ADDENDUM NO. 1

DNR-250004 GREAT COUNCIL OBSERVATION TOWER

1587 US-68,
Xenia, OH 45385

3 Reflected Ceiling Plan Demolition
1/4" = 1'-0"

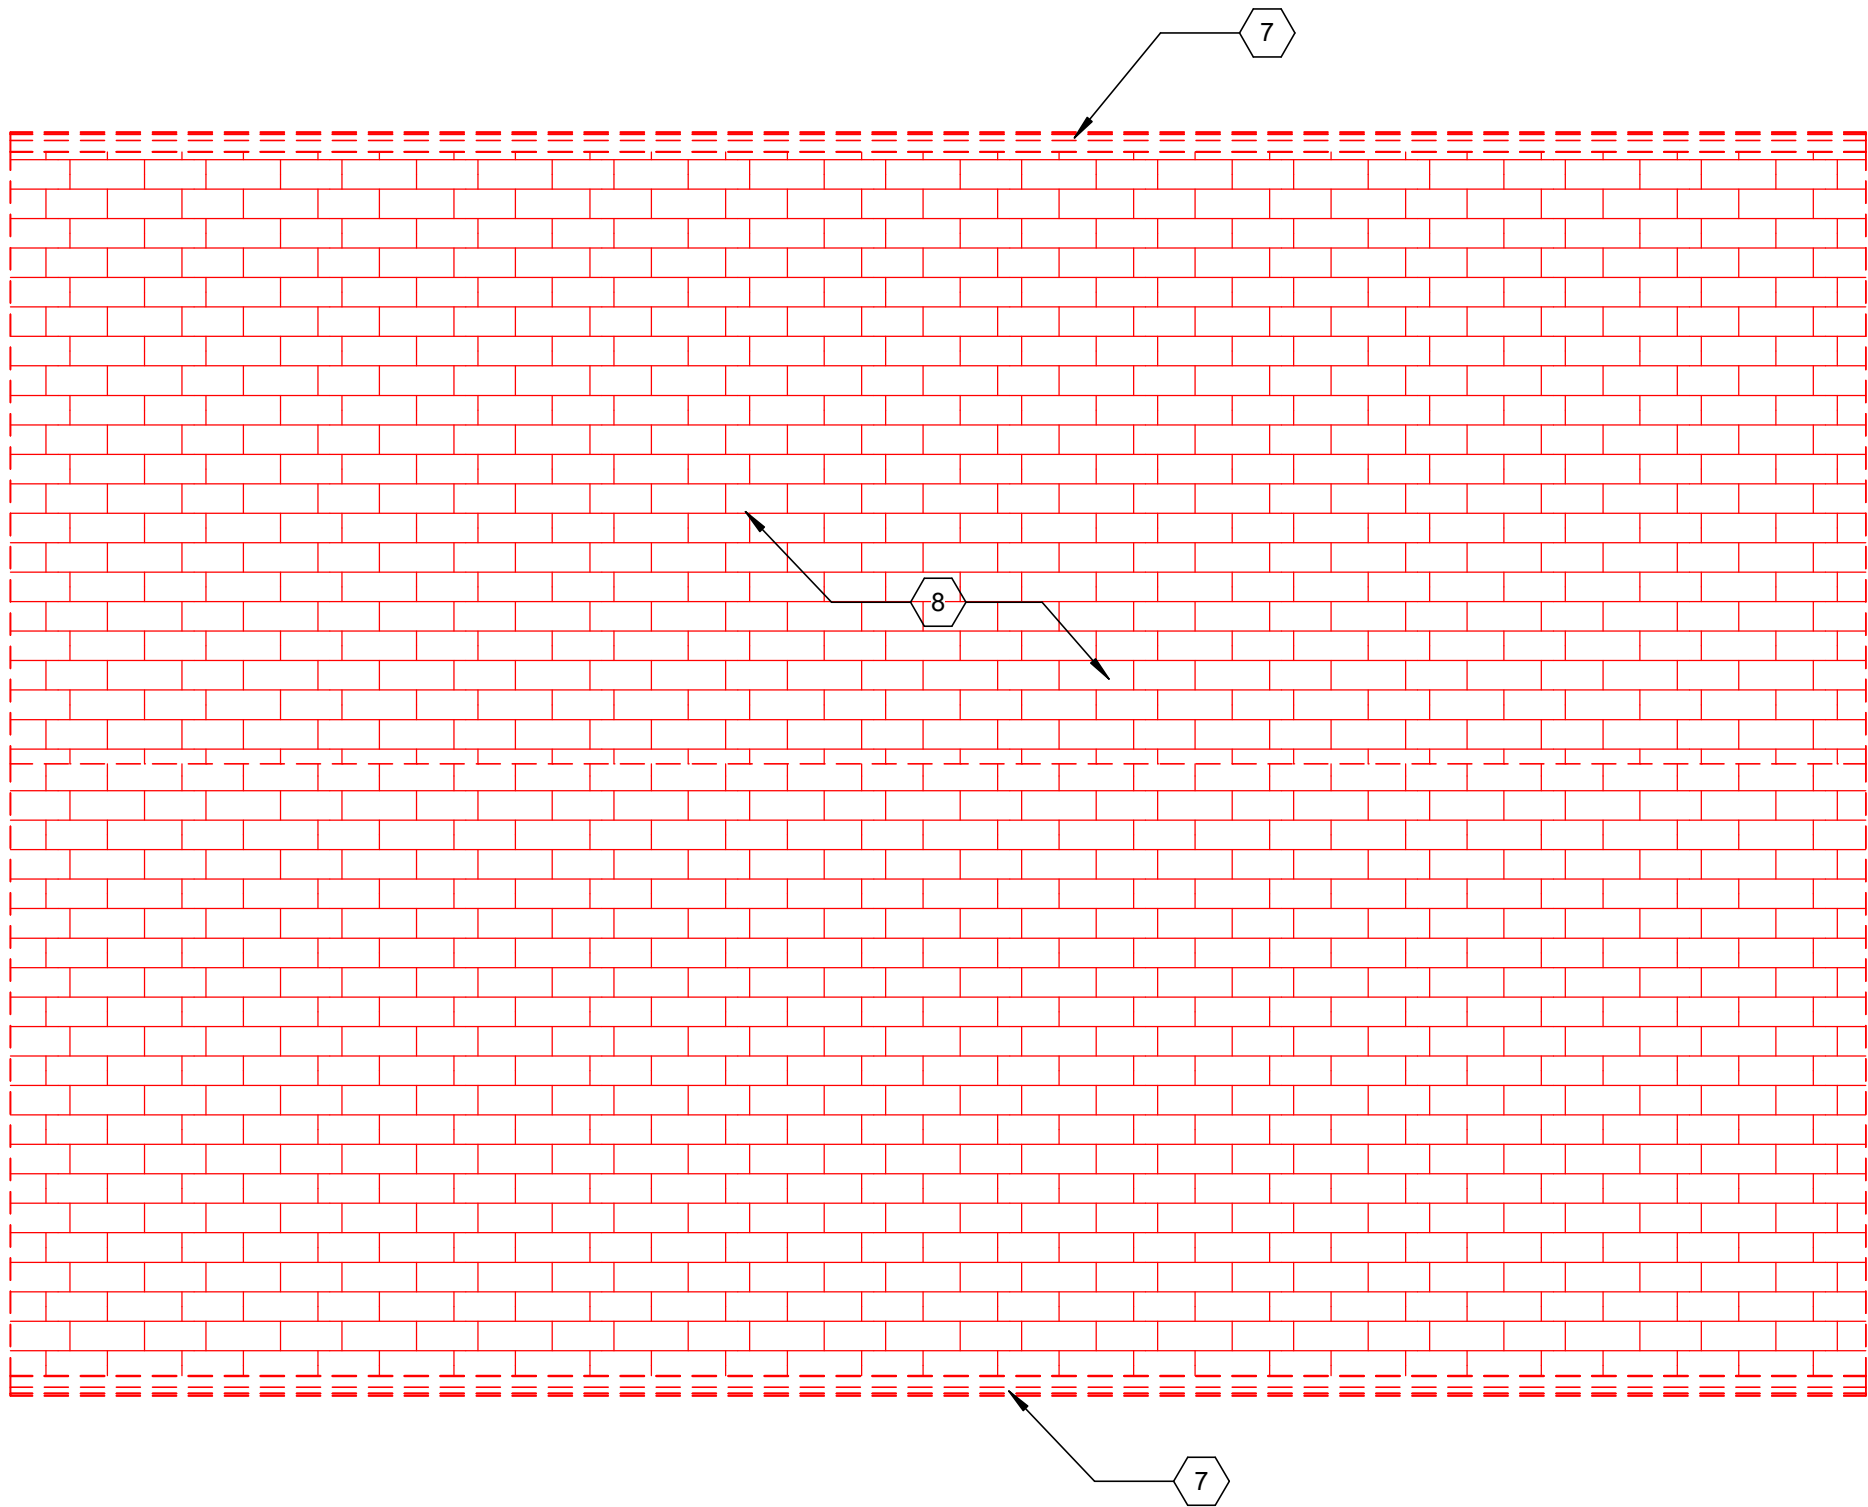
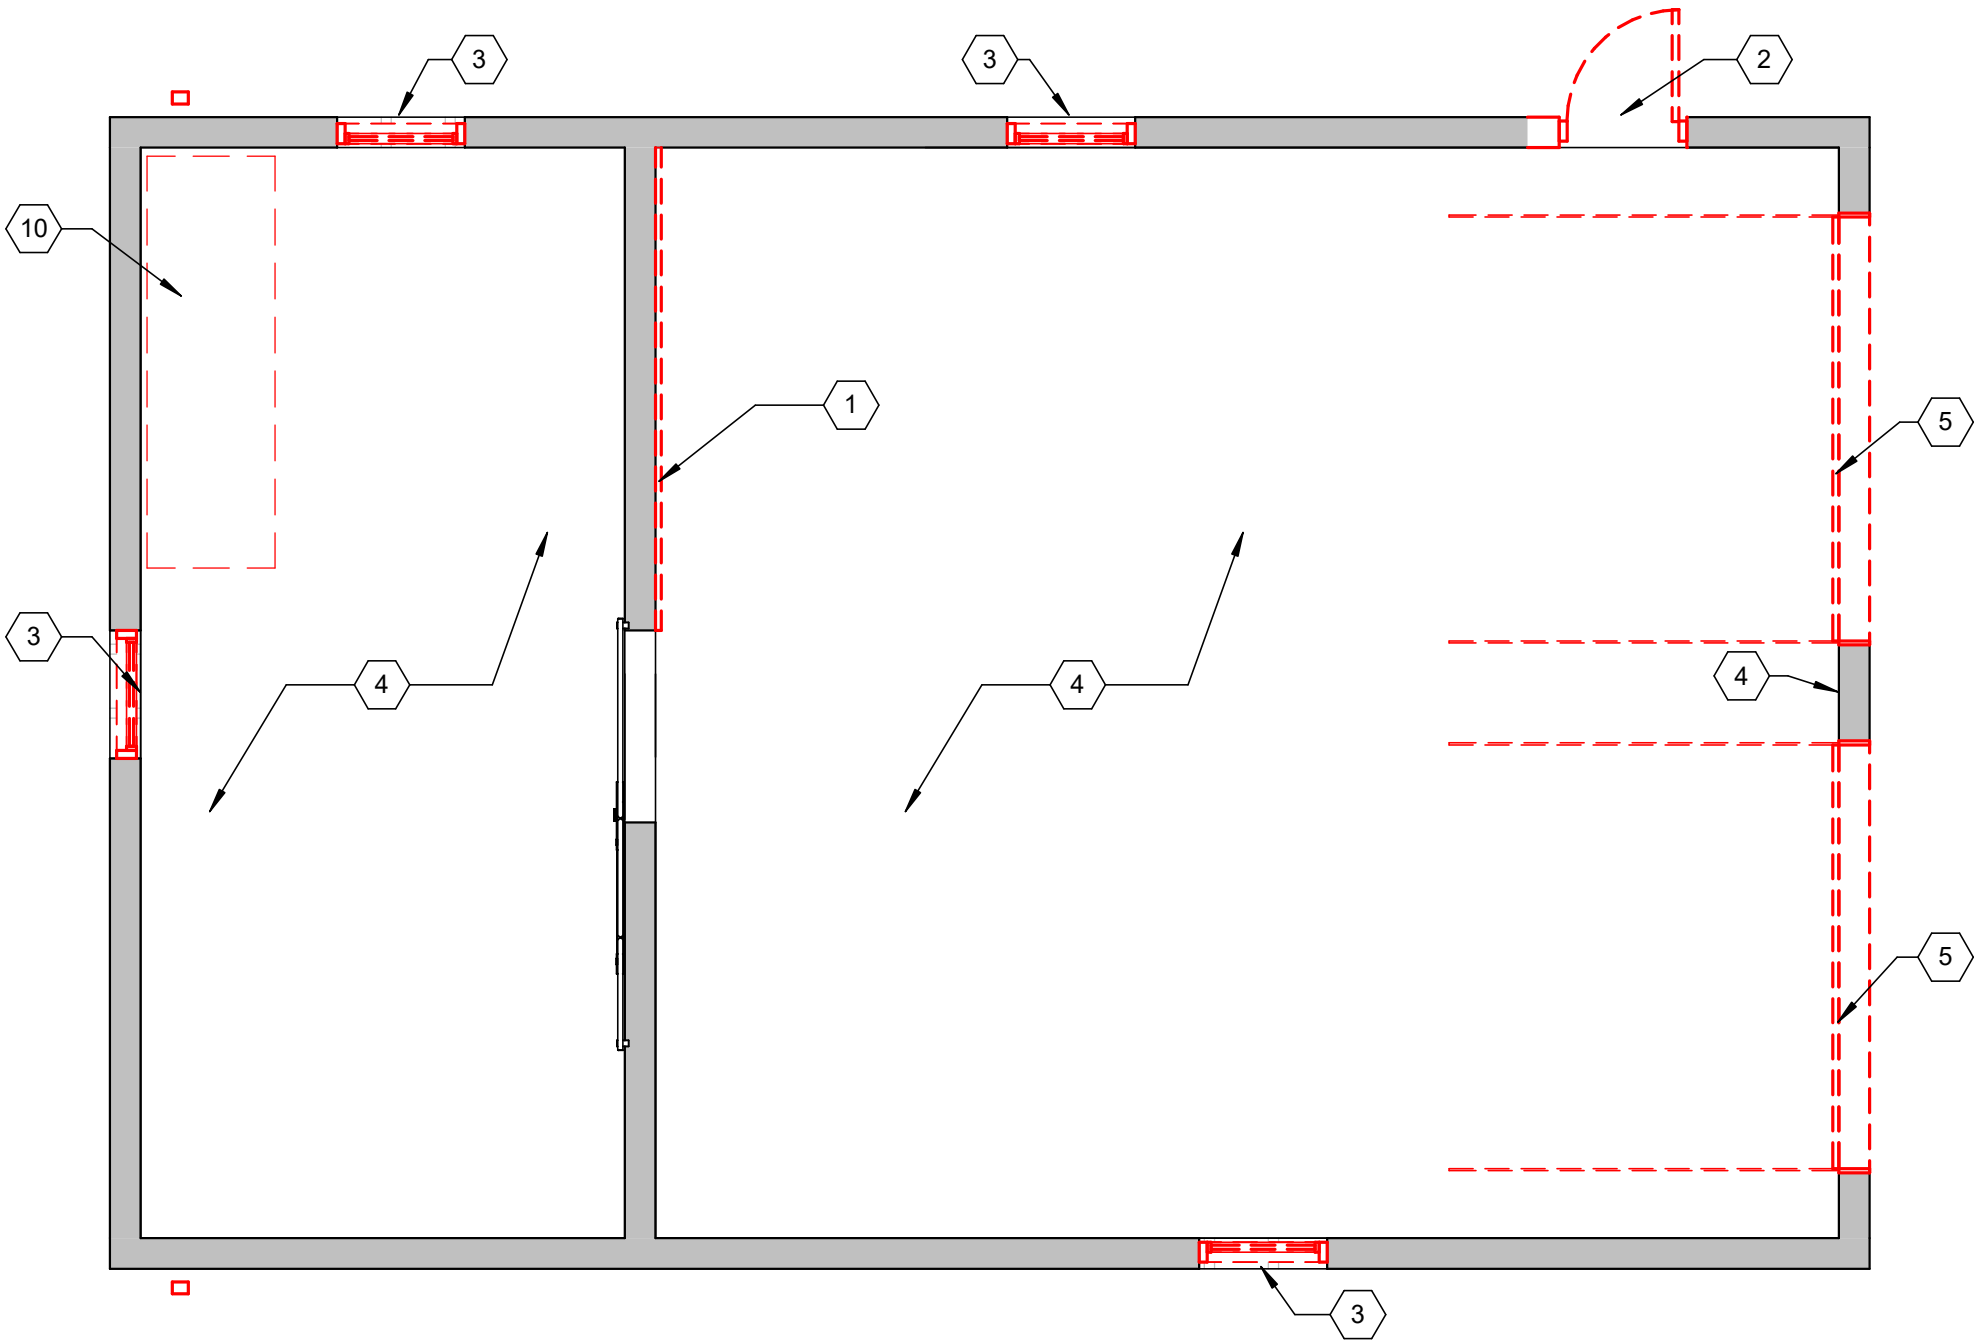
ITEM 6 M-AD1 – FLOOR PLAN DEMOTLITION

Added light fixtures for demolition to reflected ceiling plan.
